Development Review Team Comments

Project Number: PRC2021-00005

Project Name: Sherrelwood Village FDP Amendment & Filing 2 Preliminary

CAD:

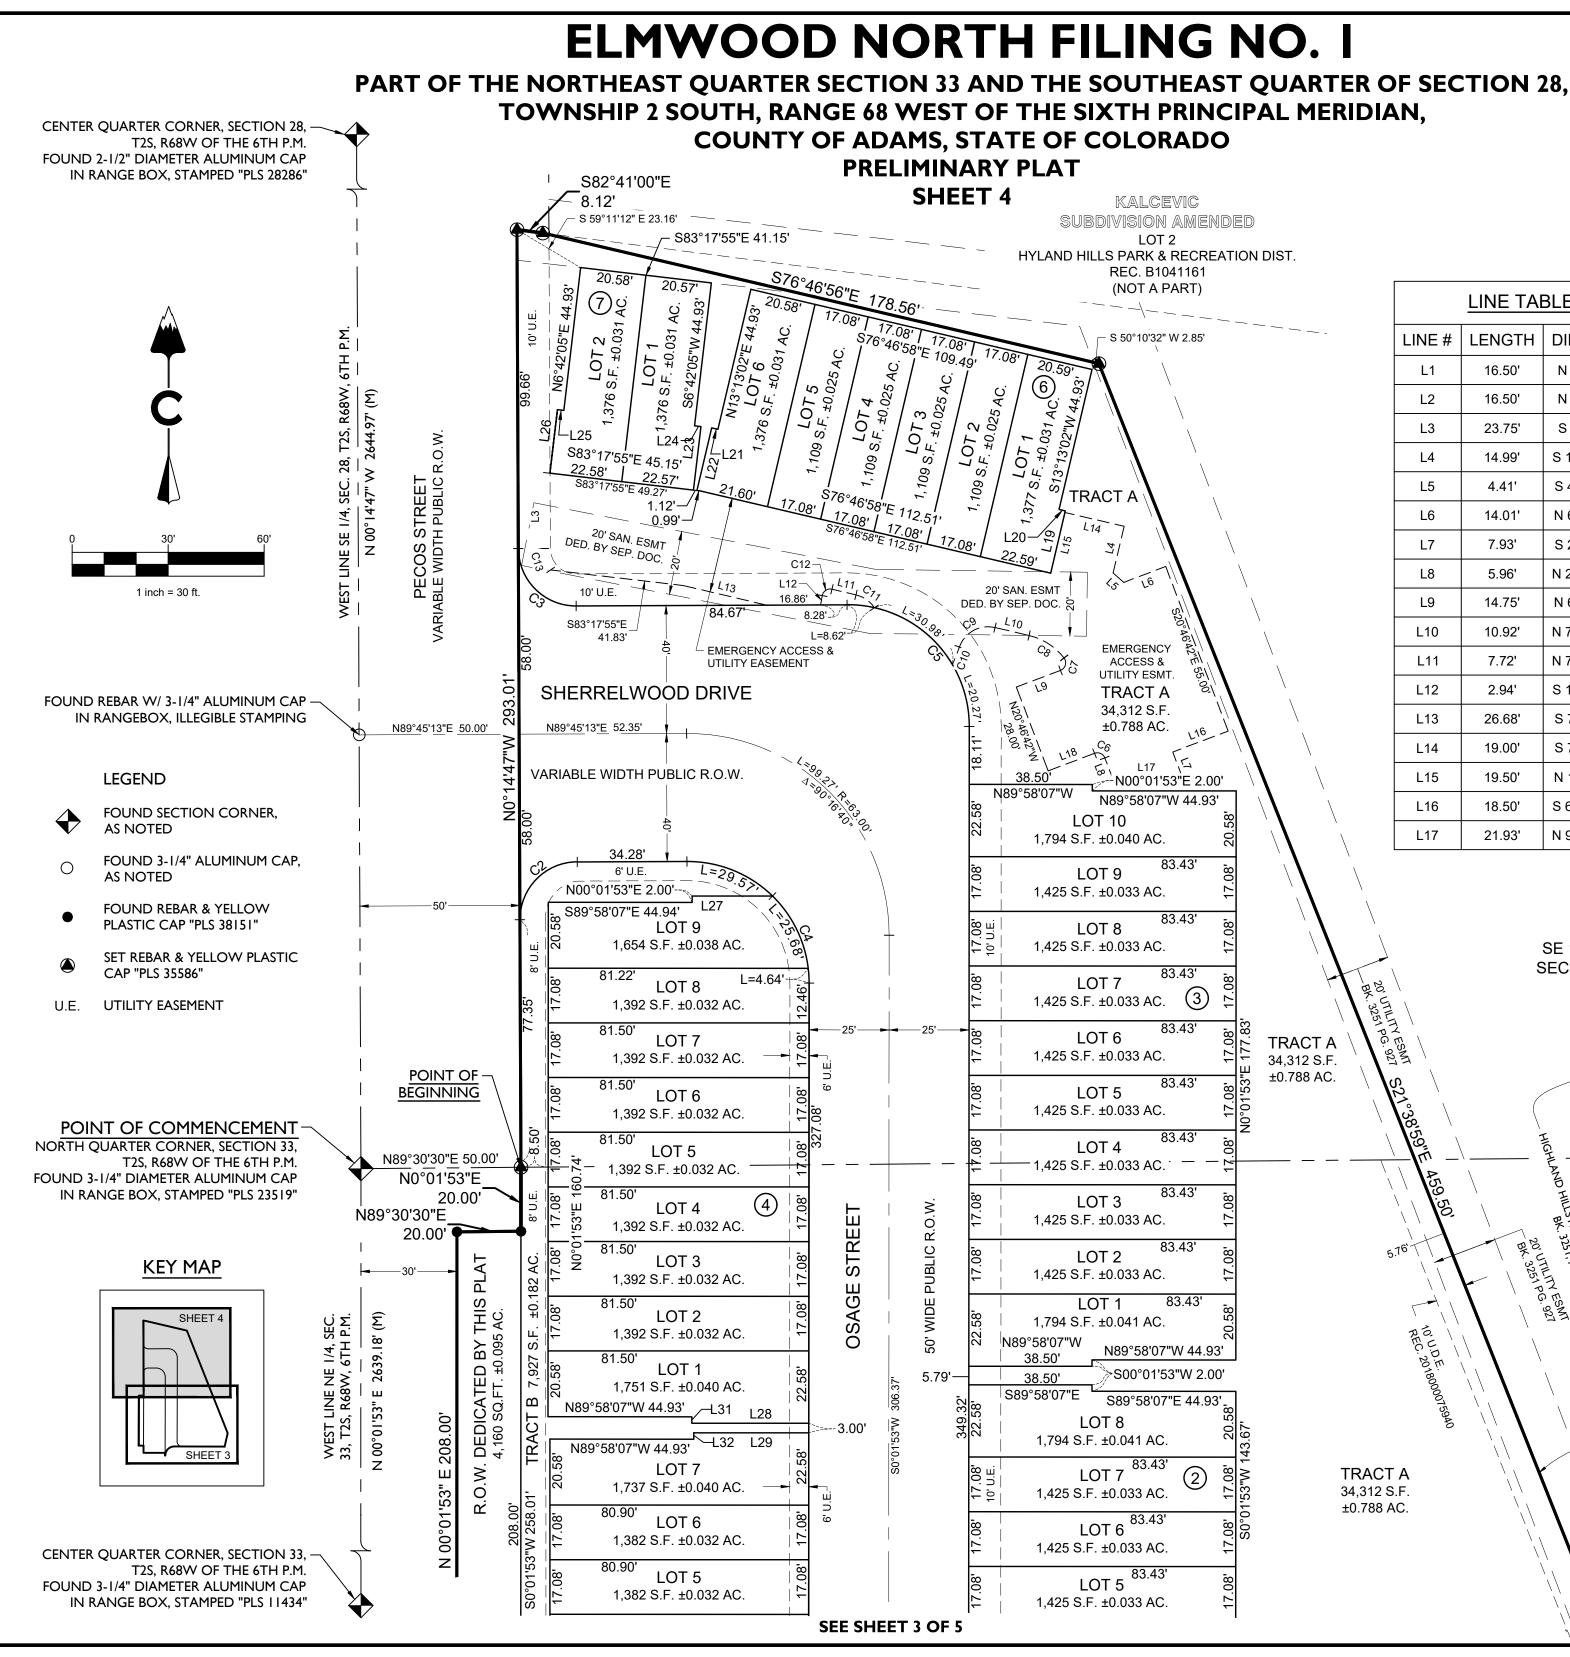
ROW3: If you want to dedicate anything to the City of Thornton, they need to have an acceptance block and affirmation on the plat. Otherwise remove this statement on Sheet 5. If the easement is off of Pecos on Sherrelwood Drive, then the note should read to be dedicated by separate instrument, or if they are a signatory, can dedicate by this plat. Adams County cannot accept dedications for other municipalities without the expressed written acceptance. RESPONSE: Thornton easement note removed from sheet 5

WOOD VILLAGE	PRC2021-00005	SHEET TITLE
INAL DEVELOPMENT PLAN - /	AMENDMENT 1	
AST QUARTER OF SECTION 28, TOWNSHIP 2		COVER SHEET
AN, ADAMS COUNTY, COLORADO PROJECT NO:	CERTIFICATE OF OWNERSHIP	SHEET NUMBER

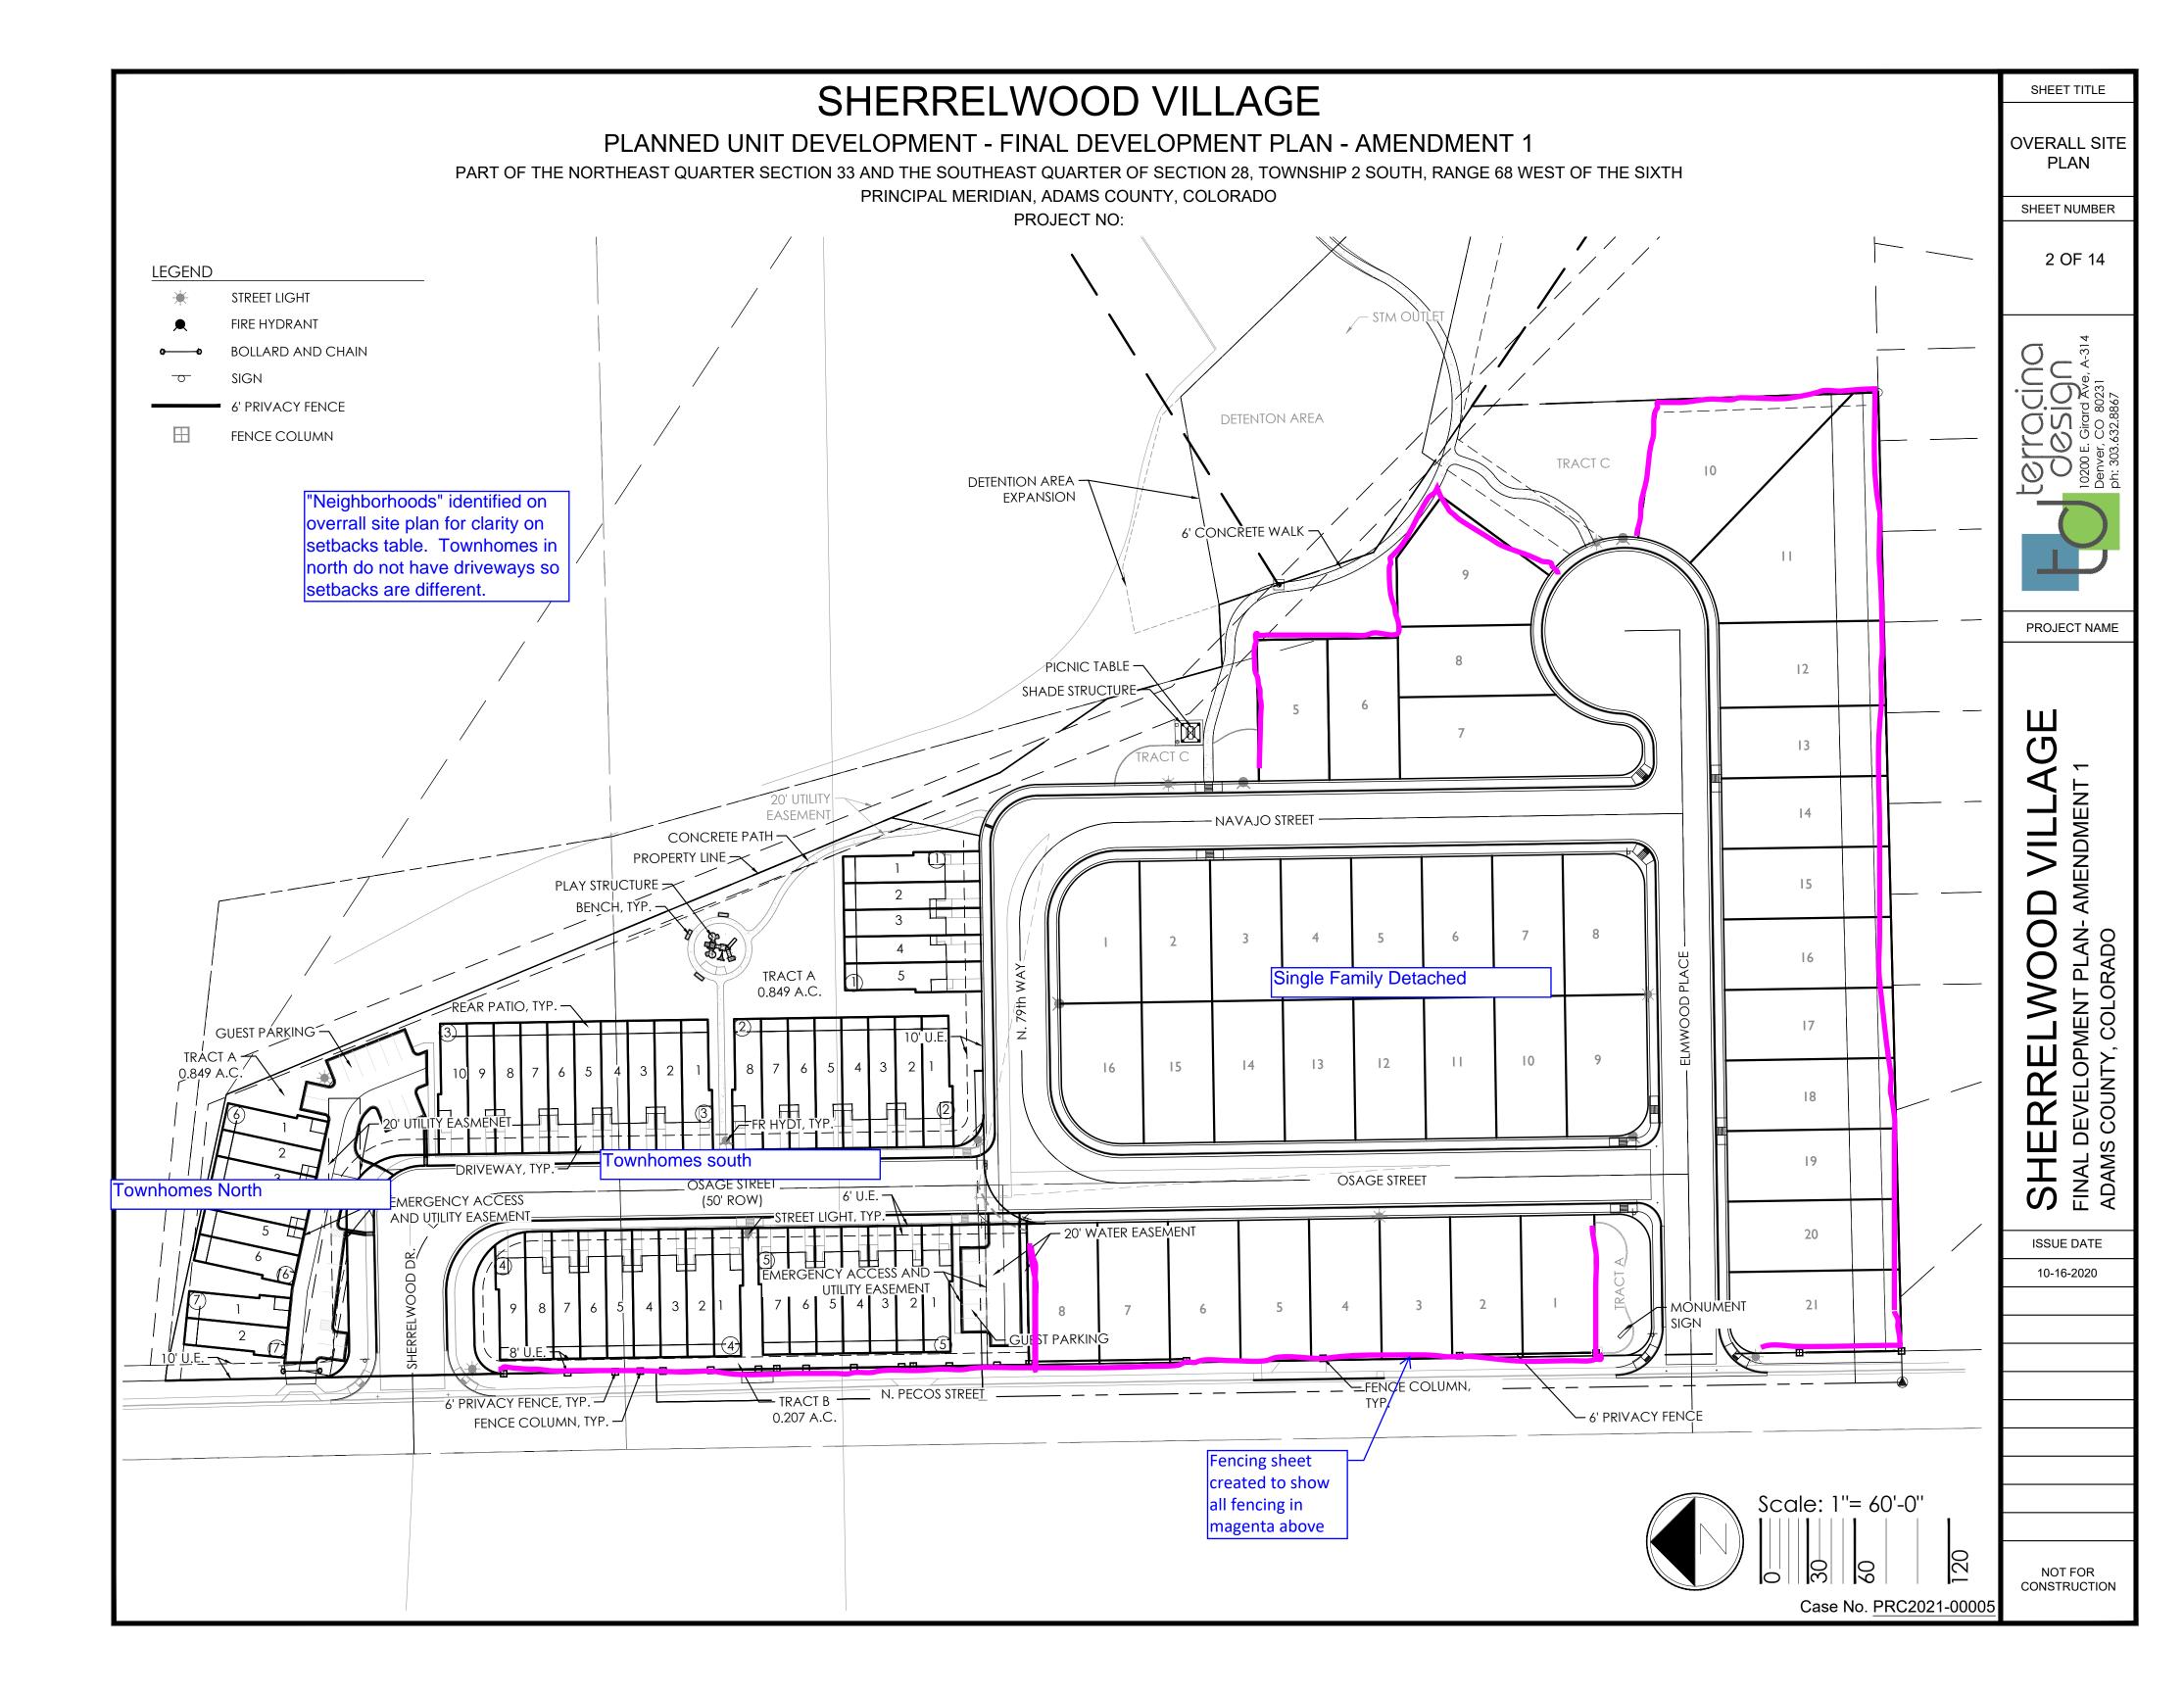
N 2 3 4 5 6 7 8 TAILS 9-11 12 S 13-14	Case number relocated to upper right Can you move this to upper-righ Case No. PRC2021-00005	NOT FOR t? CONSTRUCTION

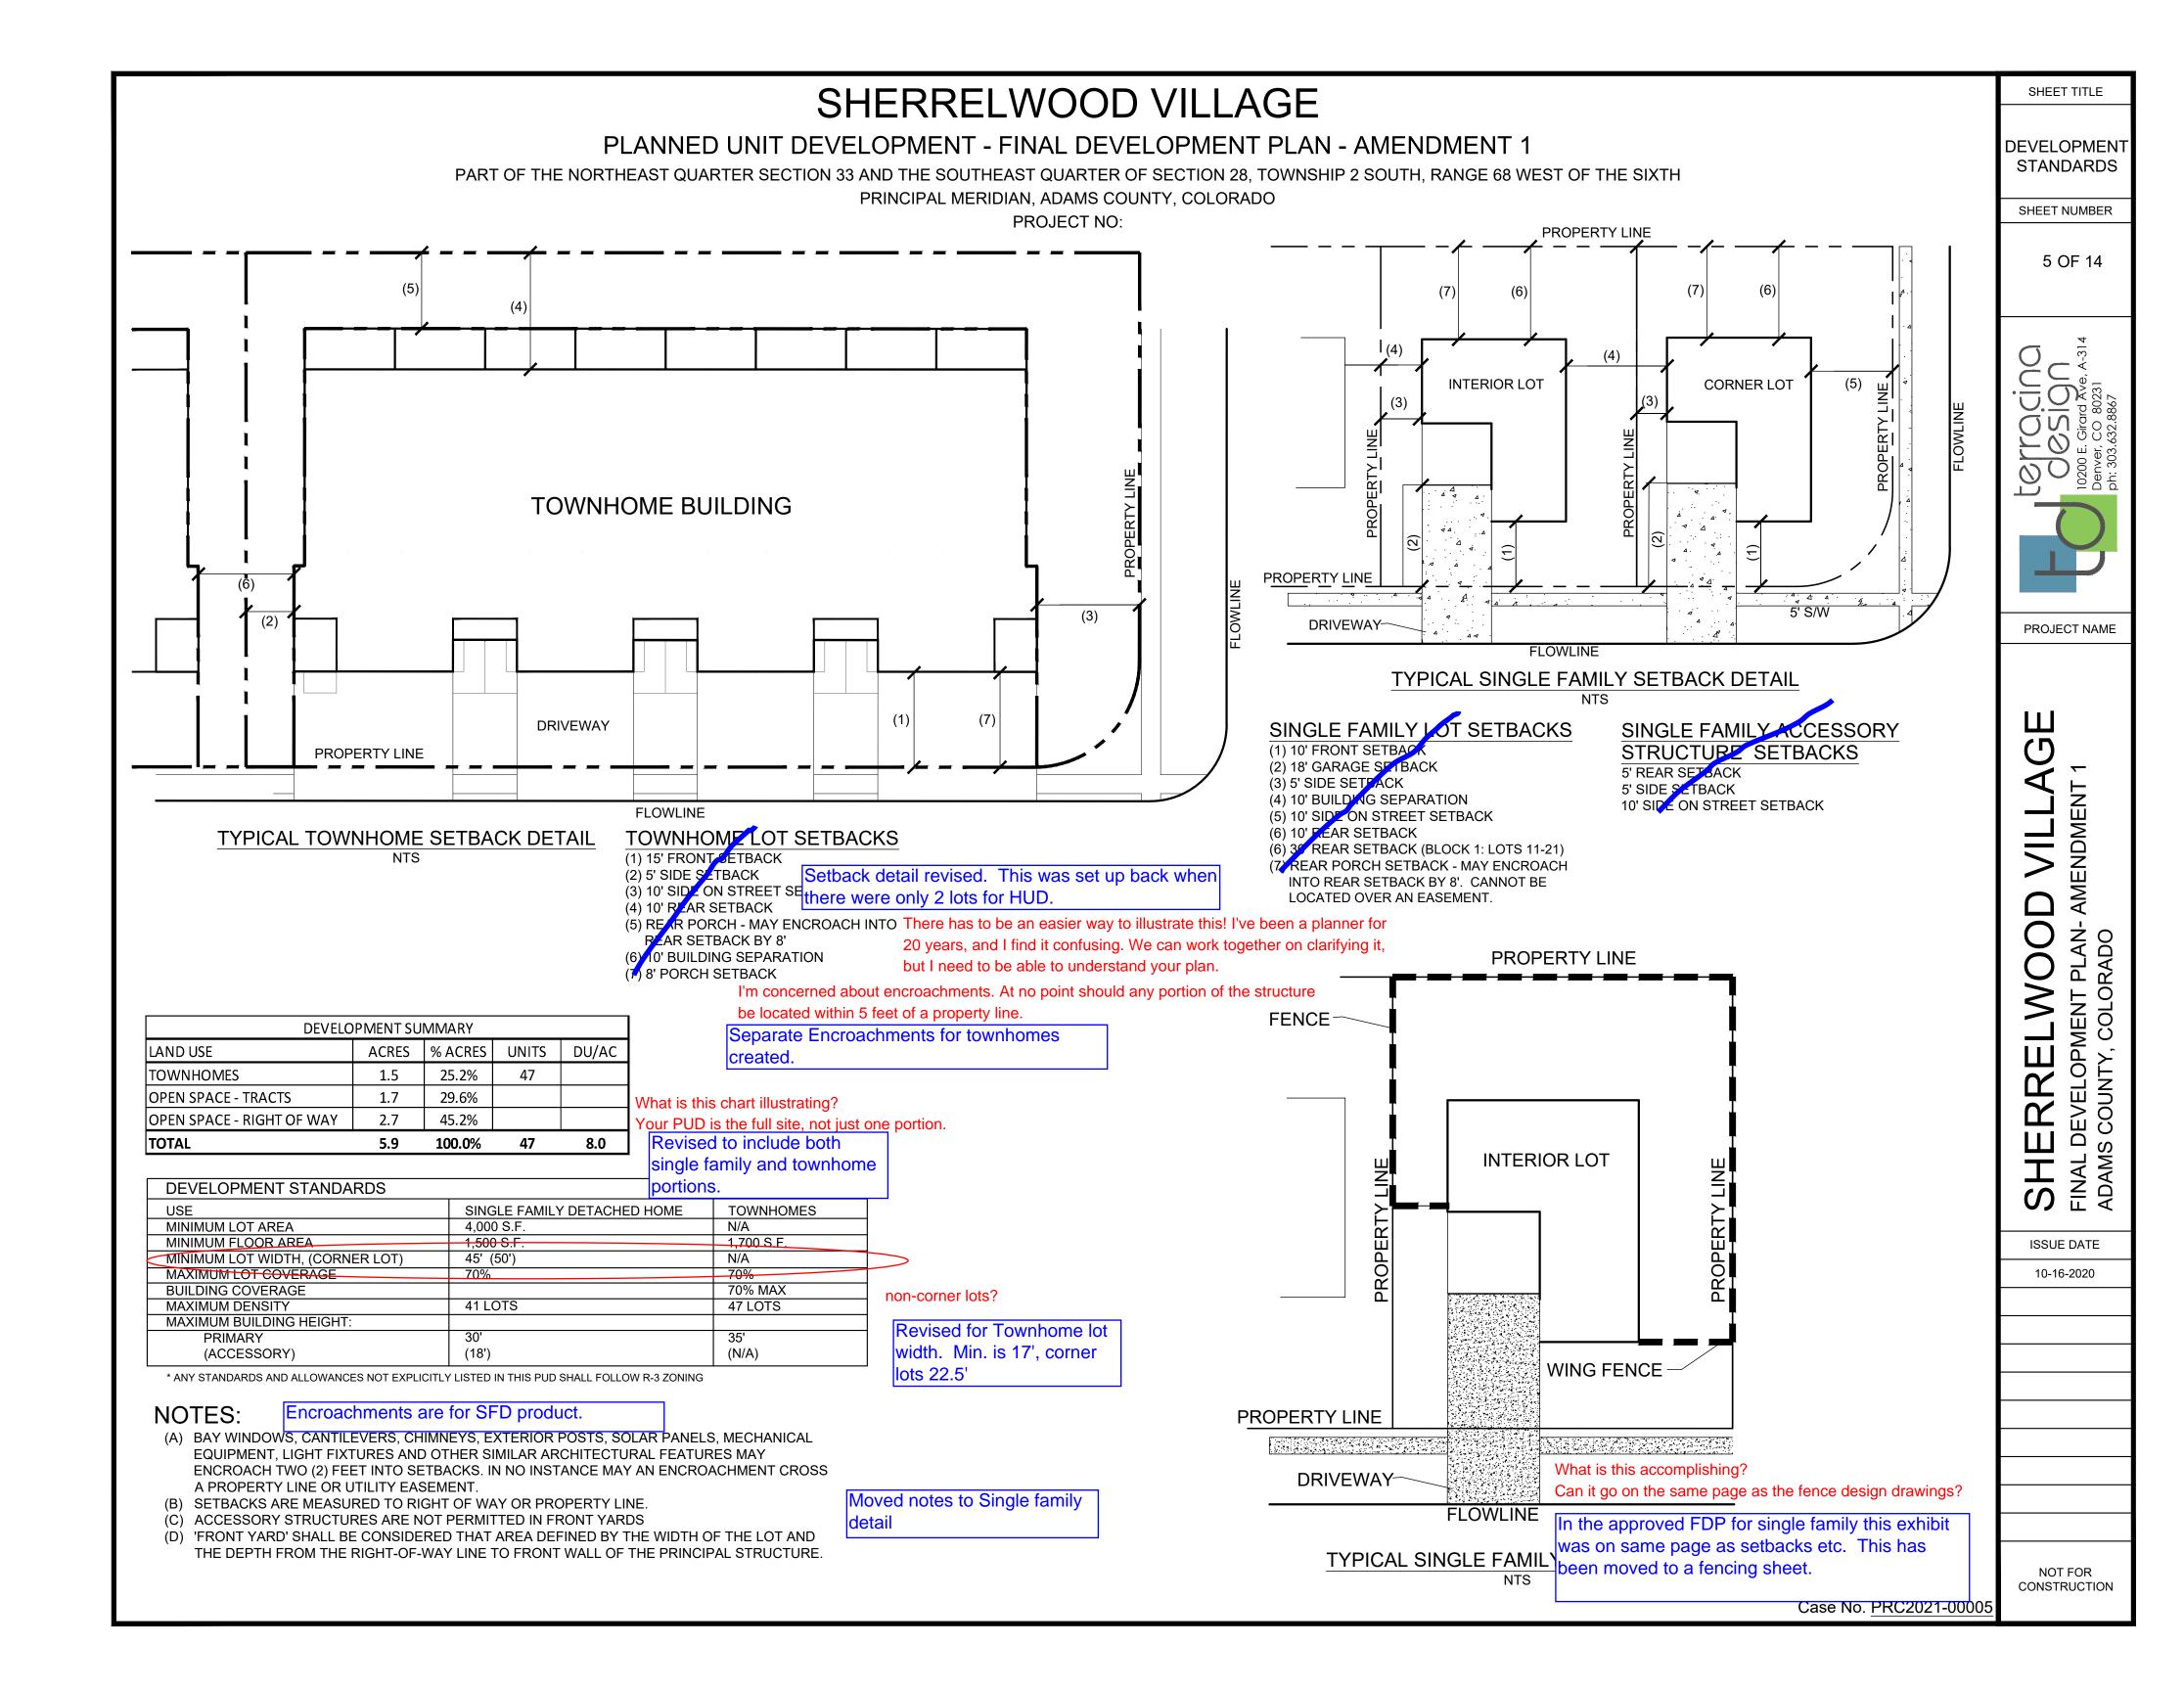
WOOD VILL
ENTRALLY LOCATED	Please identify specific tract and remove "on Osage Street" language.	
	This language is taken from the previously approved FDP for	
	SFD mailbox location. Reference to Osage St removed and Tract identified. A more specific location for the townhome mailbox is now identified on plan.	
RE ADJACENT TO		SHE FINAL D ADAMS
THE HOUSE. FENCING	Uniform fencing is preferred. I think there's a more clear and concise way to illustrate all of this. Perhaps you could provide various details on refer to fences as Type A, Type B, etc.	0) E 4
	Fencing notes exactly the same as previously approved FDP for single family lots. We can add Townhome fencing notes if necessary, but this is detailed out on sheet	ISSUE DATE
DOES NOT ALTER	10 with a plan view, elevation, fence detail, and column. This is the same fencing	10-16-2020
	that was designed along the single family homes to the south.

LAND TO SUPPORT LAND DEDICATION, NS IN CHAPTER 5 OF	PLEASE REMOVE. This does not belong on an FDP	
JCT IMPROVEMENTS	Note removed. This was part of the previous FDP	
NOOD PARK SHALL BI		
e its own trash ted dumpster.		
	Case No. <u>PRC2021-00005</u>	CONSTRUCTION
